**CENTER BUILDING IMPROVEMENTS**
**ADDENDUM #1**

June 18, 2025

ROOM 111 : LOOKING WEST

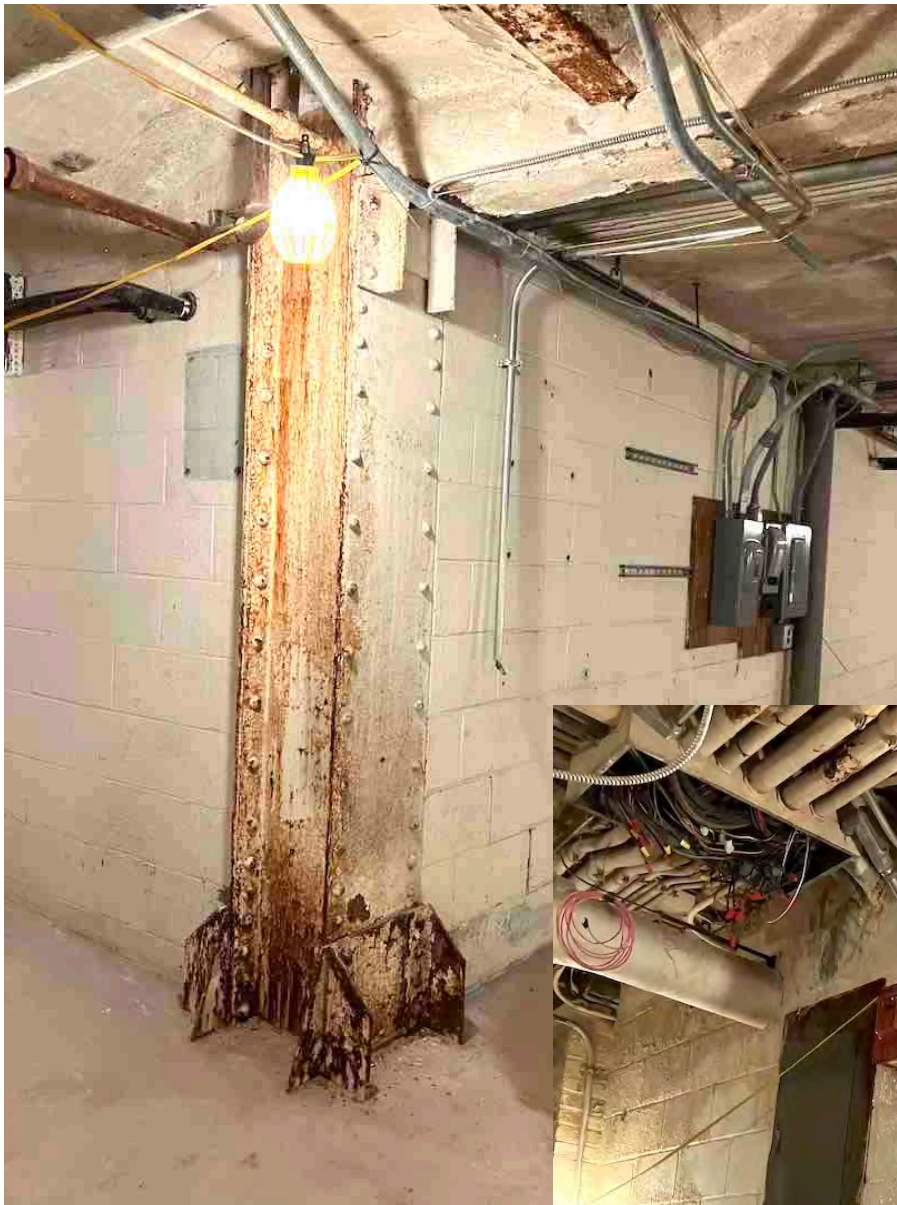
INDICATIVE OF LEVEL OF FINISH ON SOUTH SIDE OF FIRST FLOOR

BASEMENT BUILT UP COLUMN

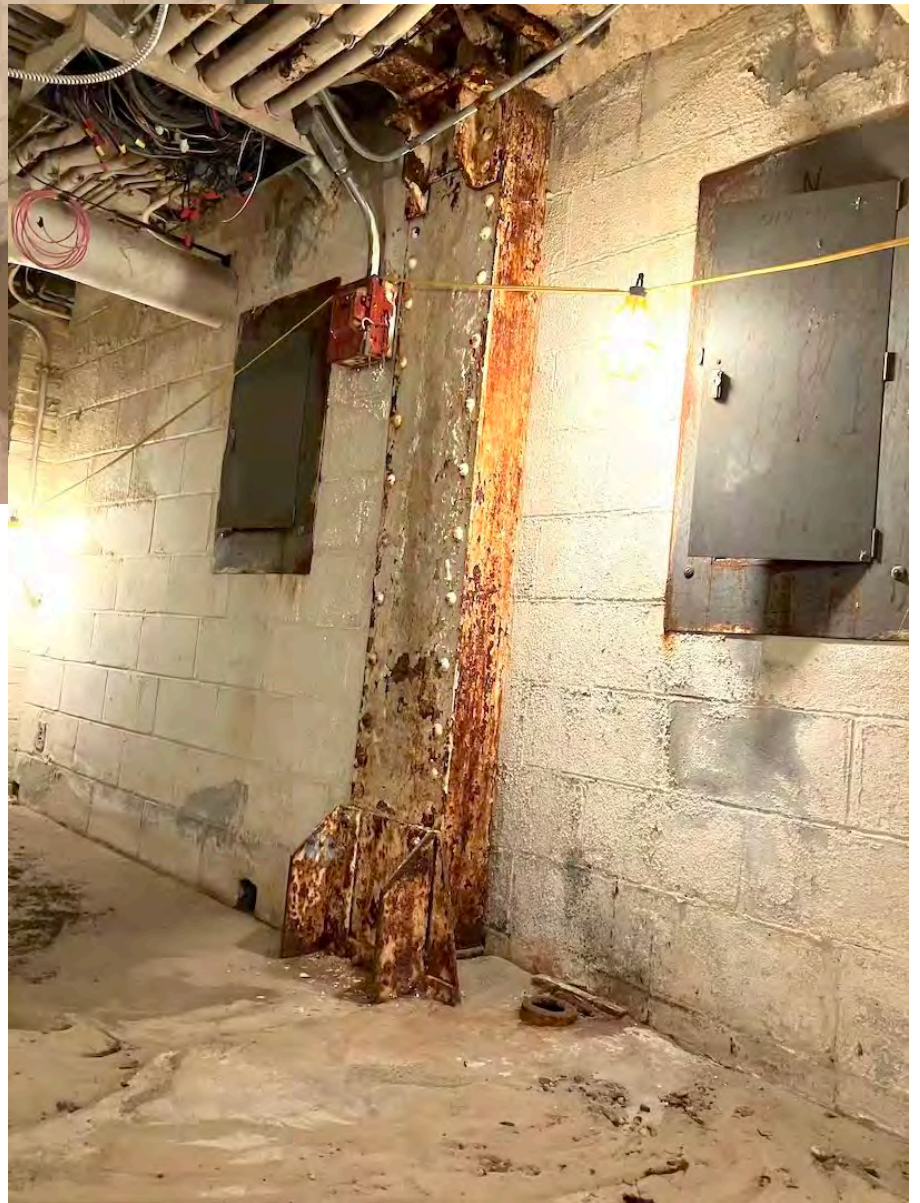
ROOM 155 SUSPENDED TERRA COTTA CEILING TO BE REMOVED  
SO THAT STEEL AND DECK ABOVE CAN BE FIREPROOFED
